INTERNATIONAL SERVICE LETTER

1501/1530

TP-1780FN

Dec. 14, 1973

T.I. MEMORY TIMING

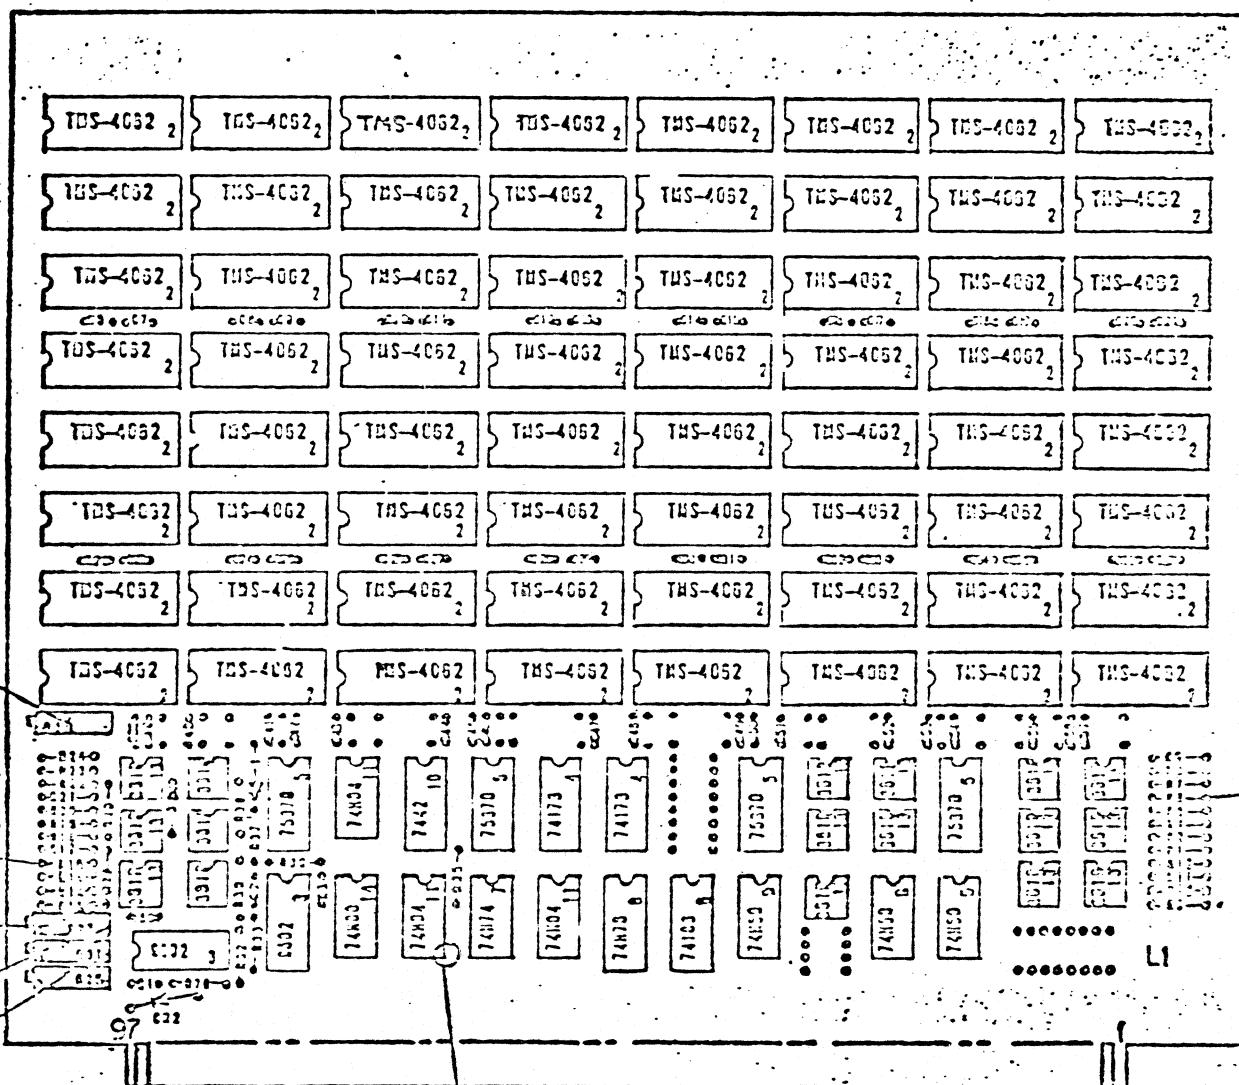
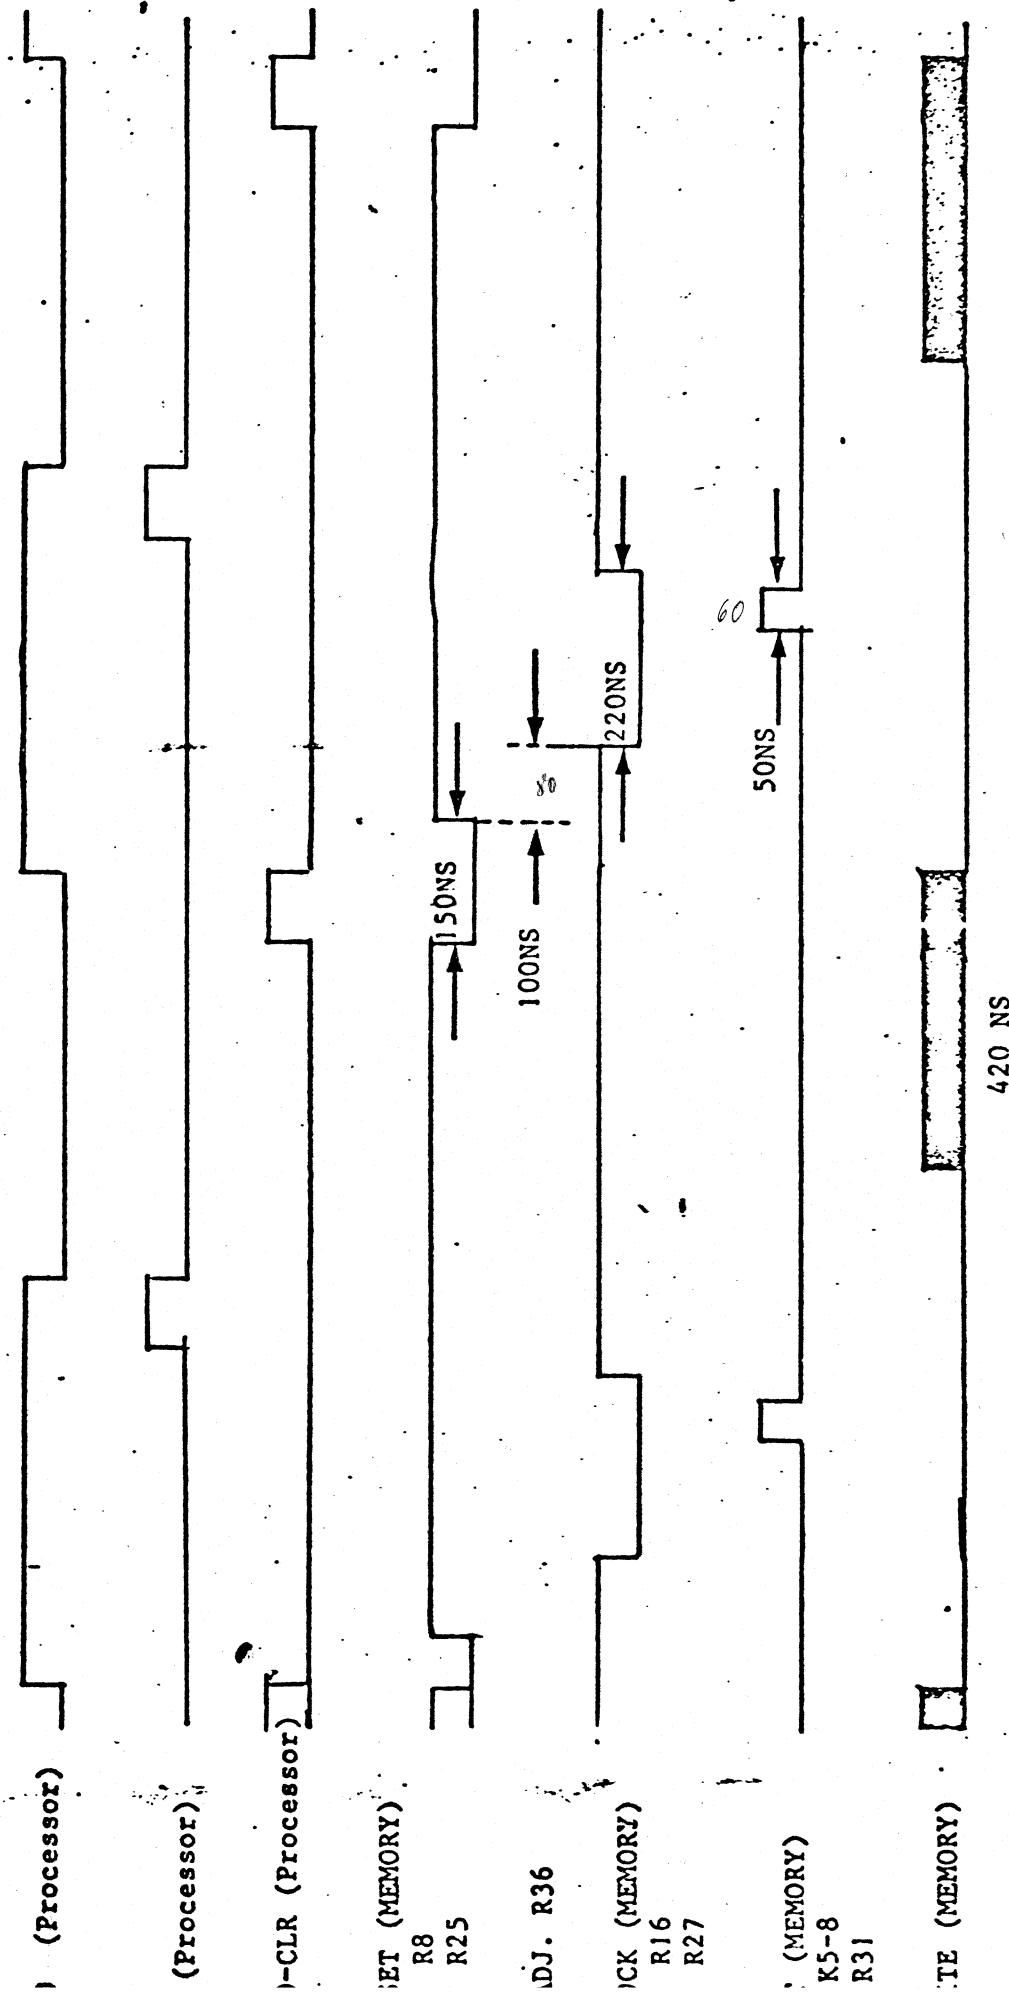
Attach Probe "A" to either end of R8. Sync on N-Reset and adjust R25 for a pulse width of 150 nsec. Set time base at 100 nsec.:Div.

Attach Probe "B" to R16 (N-CLOCK). Put time base on 100 nsec./ Div. and adjust R36 for a 100 nsec. delay (TTD) between the + Going Edge of N-RESET and the - Going of N-CLOCK.

FIGURE 1

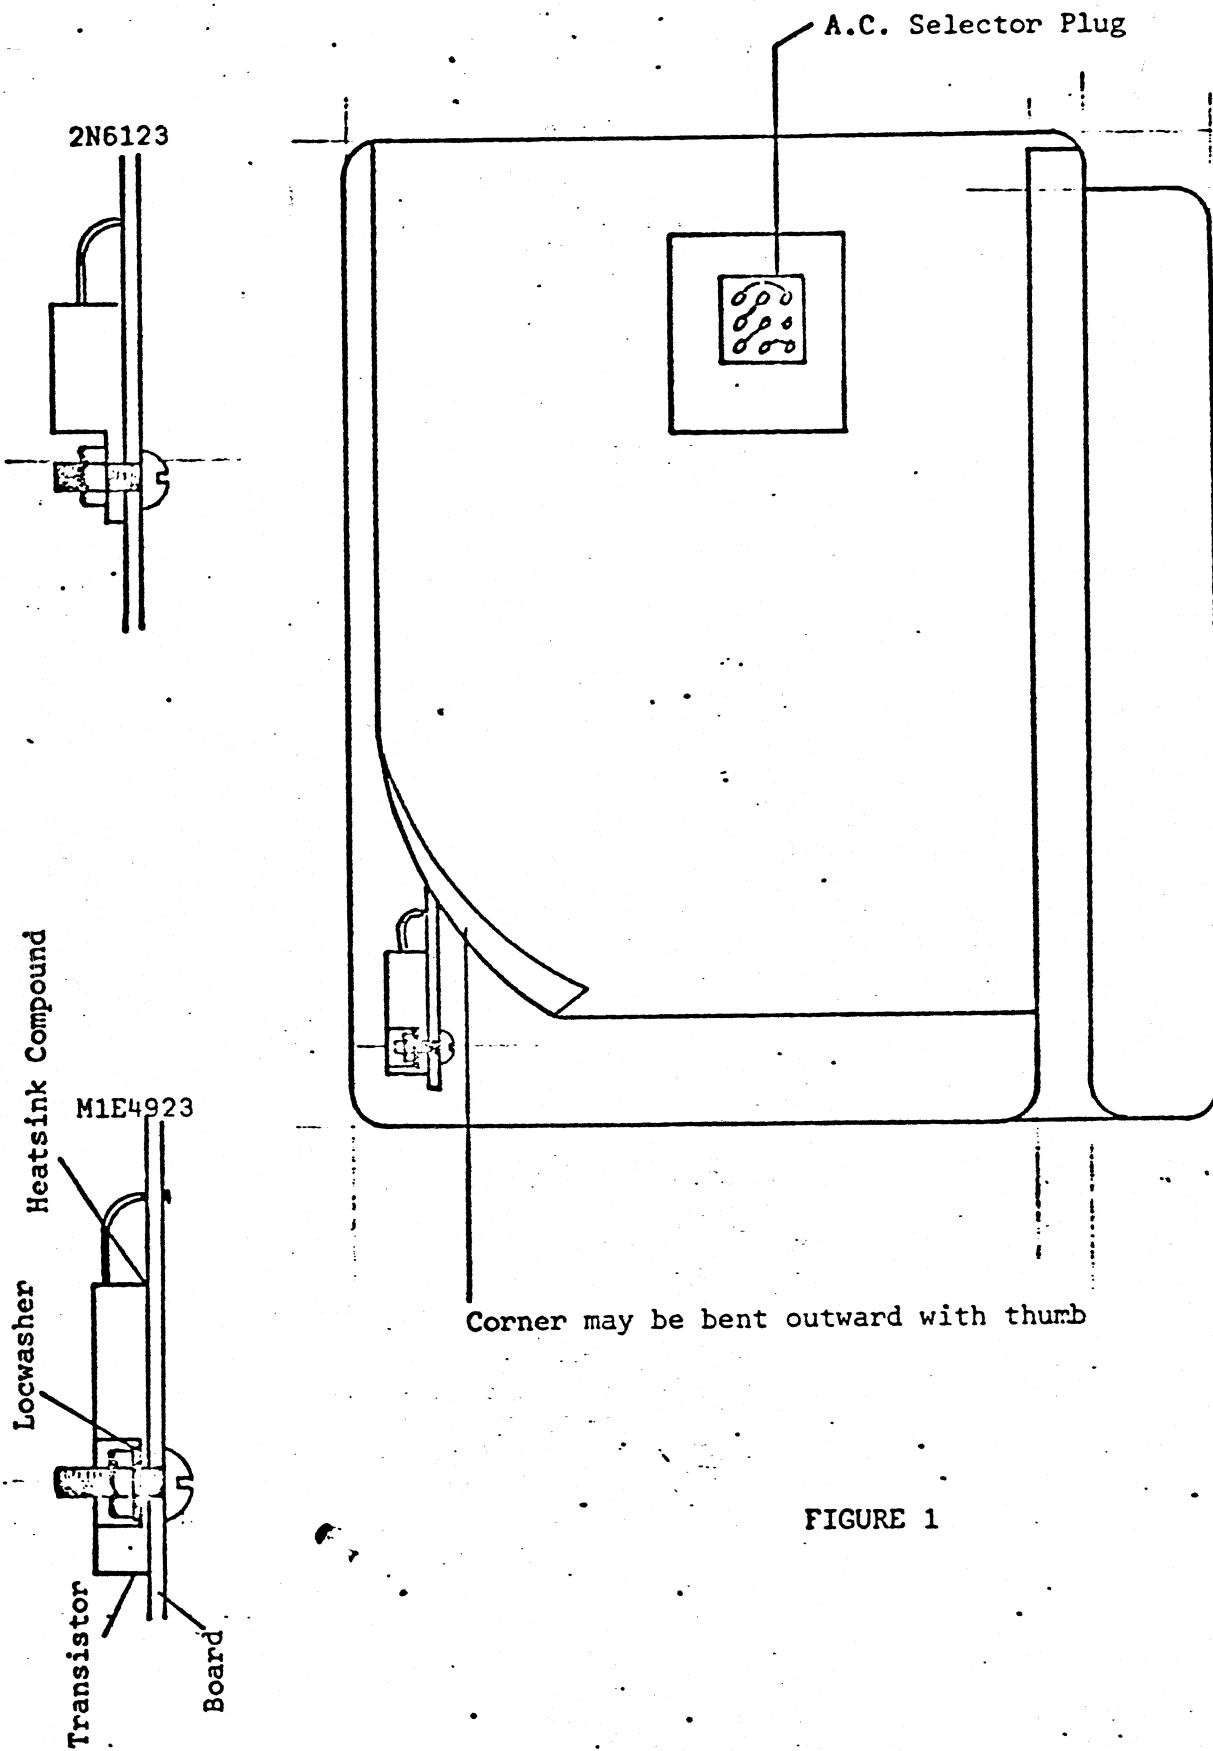
INSTRUCTIONS: To replace Q15 and Q16 which were found to be frequently defective in the power supply. If Q15 and Q16 are of the 2B6123 type, they should be replaced with MJE4923. (SBM P/N 9012094-37).

- G. Remove Q15 and Q16 from the primary board (Items A and B), by first clipping the leads, and removing the securing screws and nuts. After removing Q15 and Q16, heat and remove the transistor leads.
- H. Remove the solder from the lead holes and discard the old mounting hardware.
- I. Apply heatsink compound (approximately 1/32 inch thick) on the back of the MJE4923's and mount them on board, using the supplied hardware and solder (Figure 1).

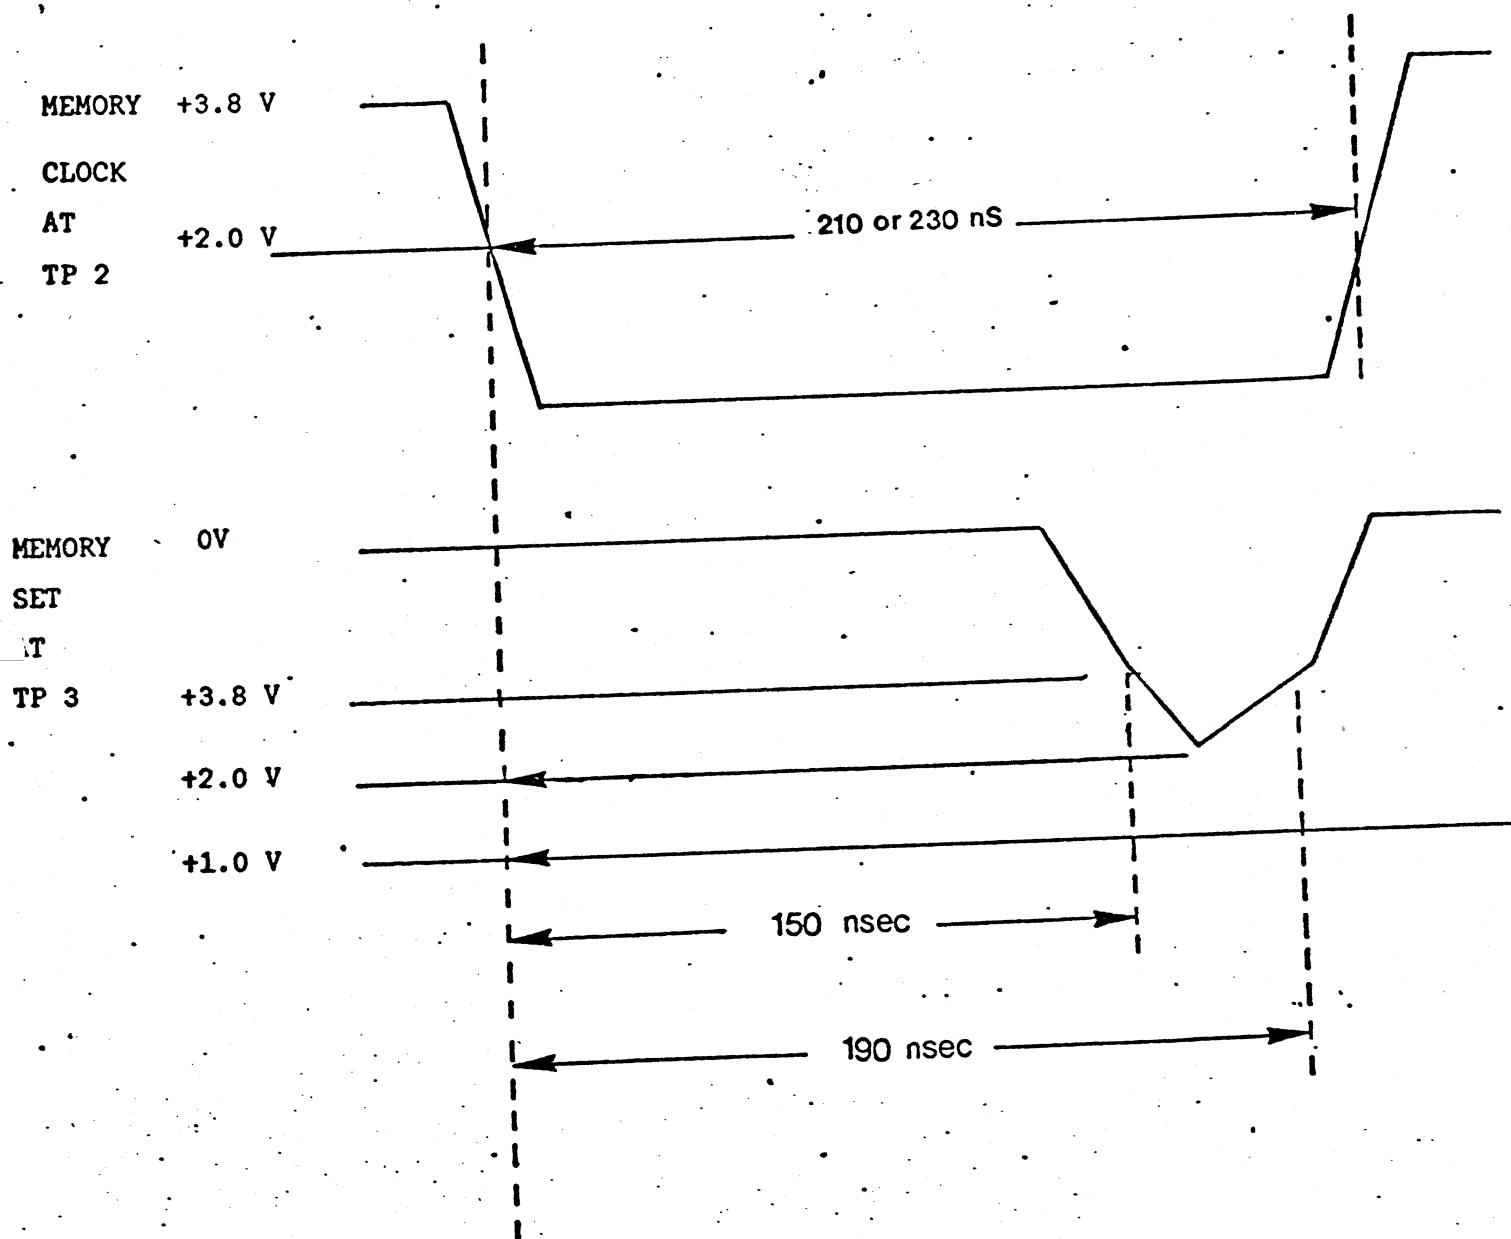
INFORMATION: For improved reliability of the Cogar Memory, a change in the memory timing is required. The clock width should now be set for 230 NS rather than 240 NS.

The Processor PCBA shows the controls and test points on the Processor Card used for proper adjustment of the memory cycle time. These controls affect:

1. The leading edge of the CLOCK pulse, from which all other timing pulses are referenced.
2. The positioning of the leading edge of the SET pulse in relation to the CLOCK pulse.
3. The width of the SET pulse.

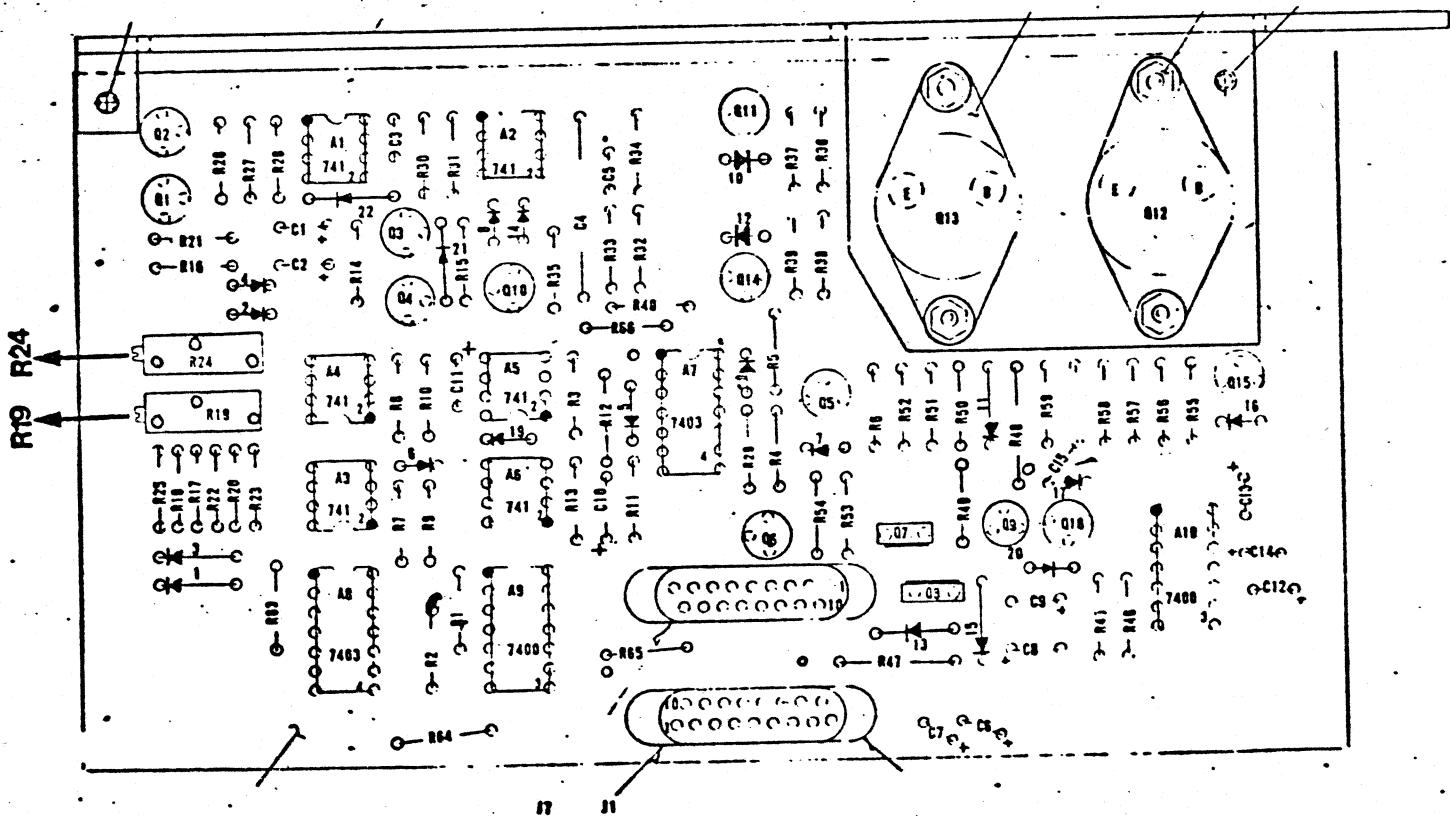
REASON: Due to the new design of the Motion Control Board for the low power decks, the speed adjustment procedure has been changed.

To adjust the forward speed R19 (The Lower POT) is used.

To increase the forward speed, turn R19 clockwise. To decrease the forward speed, turn R19 counterclockwise.

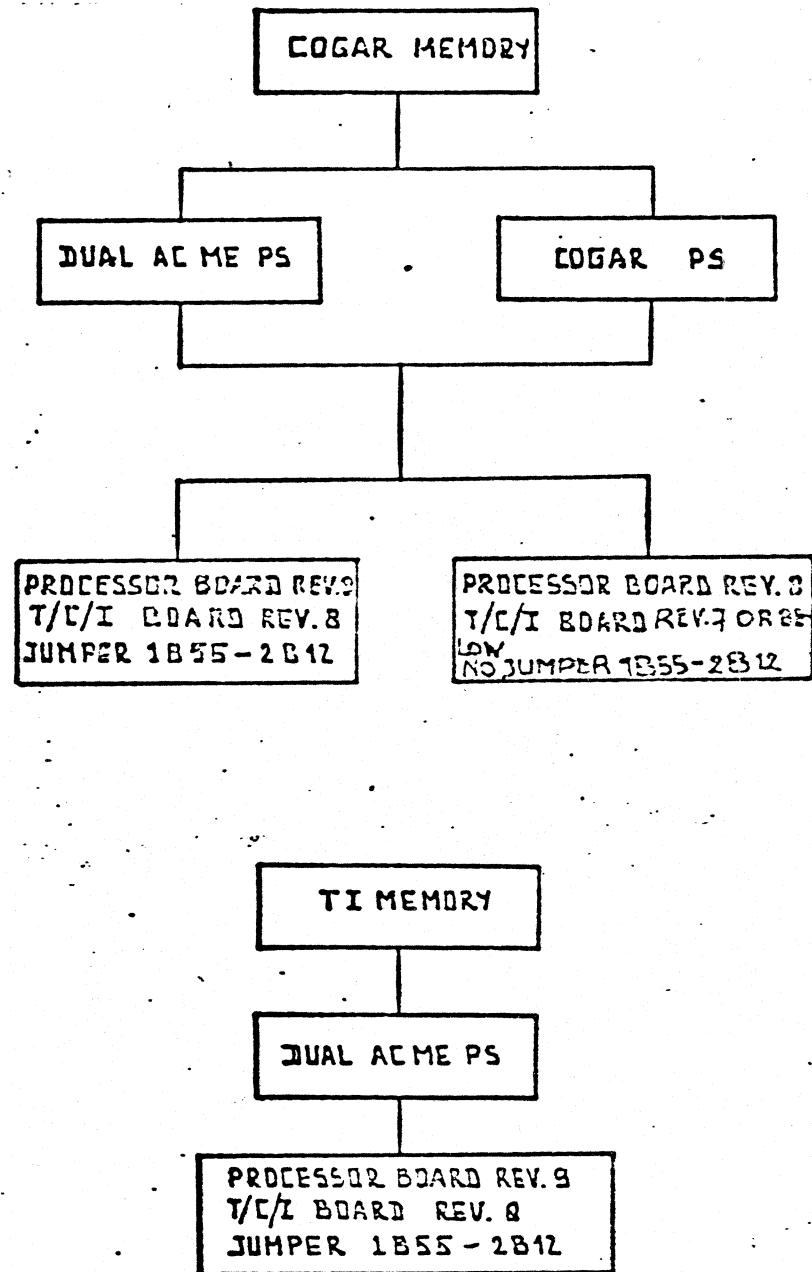
Processor Board must be Rev.9 or higher.

T/C/I Board must be Rev 8 or higher.

Jumper 1B55 to 2B12. (Rev 7 wired moduled)

If processor board is at Rev 8 or less the T/C/I board must supply P-Call-Zone at pin 1B60, ie. Rev 7 or below T/C/I boards must be used. If Processor board is at Rev 9 or above the T/C/I board must supply N-Call-Zone at pin 1B60, ie. Rev 8 or higher. In addition a jumper must be added to 1B55 from 2B12.
